SLIDE-OUTS

The pressure angle (PA) on all Lippert Through Frame slide-out gear packs has changed from 14.5PA to 20PA. This will require a change in replacement parts used for through frame slide-outs. See TI 001 to determine the gear rack and spur gear currently in use.

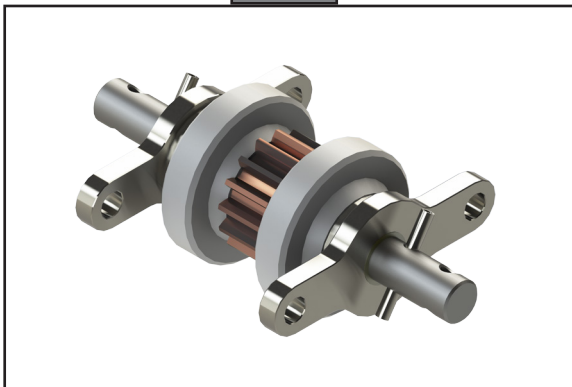
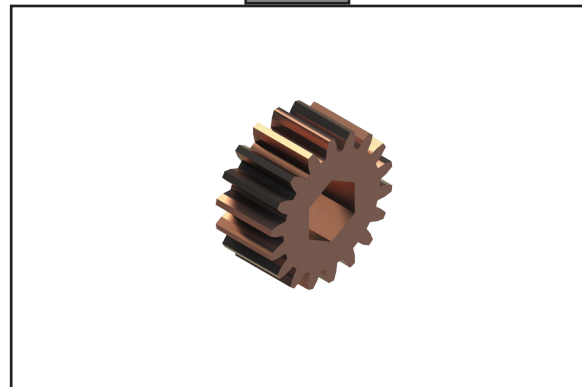
For customers with broken teeth in a gear pack, replacement parts will be a new gear pack (20PA) and an original spur gear (14.5PA). The pressure angle of the spur gear on the new gear pack will not mesh with the pressure angle of the old gear rack. The new gear pack will need to be disassembled, and the spur gear on the new gear pack will need to be replaced with the spur gear **122739**.

- 2" x 2" Gear Pack Assembly (20PA) - [281331](#) (Fig. 1)
- 2 ½" x 2 ½" Gear Pack Assembly (20PA) - [324869](#) (Fig. 2)
- 2 ½" x 2 ½" Heavy Duty Steel Gear Pack Assembly (20PA) - [123356](#) (Fig. 3)
- Spur gear (14.5PA) - **122739** (Fig. 4)

1. Remove the roll pin (if equipped).
2. Remove the mounting plate.
3. Remove the spur gear.
4. Replace the spur gear with spur gear **122739**.
5. Reverse the process.

Fig. 5.1

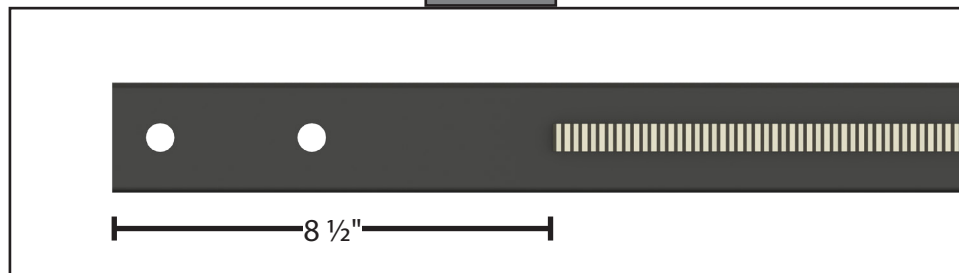
For customers with broken teeth in a gear rack, replacement parts will be two new inner arms, and two new gear packs. Both inner arms and gear packs must be replaced at the same time in order to maintain timing. The pressure angle of the spur gear on the new gear pack will not mesh with the pressure angle of the old gear rack.

- 2" x 2" Inboard (20PA) - **163778** (Fig. 5.1, Fig 5.2)
- 2" x 2" Outboard (20PA) - **145736** (Fig. 6.1, Fig 6.2)
- 2" x 2" Gear Pack Assembly (20PA) - **281331** (Fig. 1)
- 2 ½" x 2 ½" Inboard (20PA) - **143710** (Fig. 7.1, Fig 7.2)
- 2 ½" x 2 ½" Outboard (20PA) - **143707** (Fig. 8.1, Fig 8.2)
- 2 ½" x 2 ½" Gear Pack Assembly (20PA) - **324869** (Fig. 2)
- 2 ½" x 2 ½" Heavy Duty Steel Gear Pack Assembly (20PA) - **123356** (Fig. 3)
